Qualification of ASE as an Additional Assembly and Test Site of SOT-223 Commercial Power Mosfets

Product Group: Vishay Siliconix/July 22, 2013/PCN-SIL-0382013 Rev 0

Appendix A: Tape and Reel Comparison

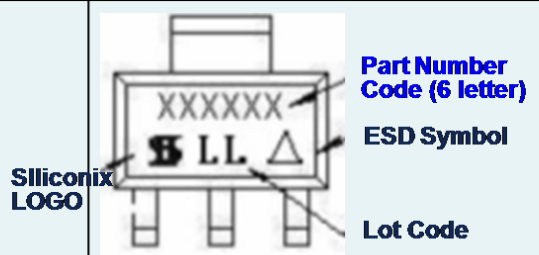
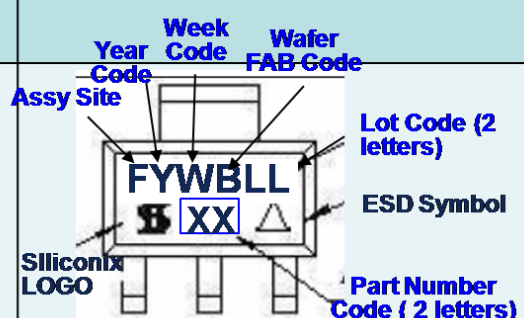
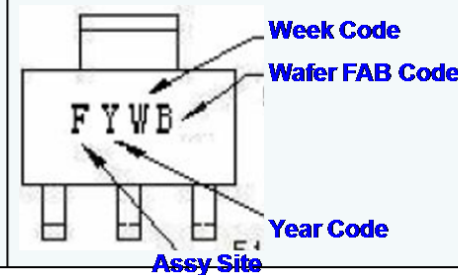
The dimensions of the Tape and the Reel supplied by ASE are slightly different than that provided by Carsem, our current sub-contractor for SOT-223 packages. A comparison with details can be found in Appendix A below.

Dimension Description	EIA Carrier Tape Standard Dim	Vishay Siliconix Carrier Tape		ASE Weihai Carrier Tape	
		Min	Max	Min	Max
Sprocket Hole Diameter	D0	1.5	1.6	1.5	1.6
Pocket center hole diameter	D1	1.50	1.60	1.5	
Sprocket hole center to tape edge	E1	1.65	1.85	1.65	1.85
Sprocket hole pitch	P0	3.90	4.10	3.90	4.10
10xP0	P10			39.80	40.20
Sprocket Hole center to pocket hole center, x	P2	1.90	2.10	1.90	2.10
	R (ref)				
pocket edge to tape edge(btm)	S1	NA	NA	NA	NA
Carrier tape thickness	T	0.25	0.35	0.25	0.35
cover tape thickness	T1	0.048	0.058	0.04	0.06
Pocket length (measured at pocket top side)	B1	NA	NA	NA	NA
Sprocket hole center to edge of tape	E2	13.85	14.65	10.05	10.5
Sprocket Hole center to pocket hole center, y	F	7.40	7.60	5.45	5.55
Pocket pitch	P1	11.90	12.10	7.9	8.1
Cover tape + T+Ko	T2	2.398	2.708	2.09	2.41
Carrier tape width	W	15.7	16.3	11.9	12.15
Pocket width	A0	6.9	7.1	6.95	7.15
Pocket length (measured at pocket top side)	B0	7.4	7.6	7.3	7.5

Pocket depth	K0	2.1	2.3	1.8	2
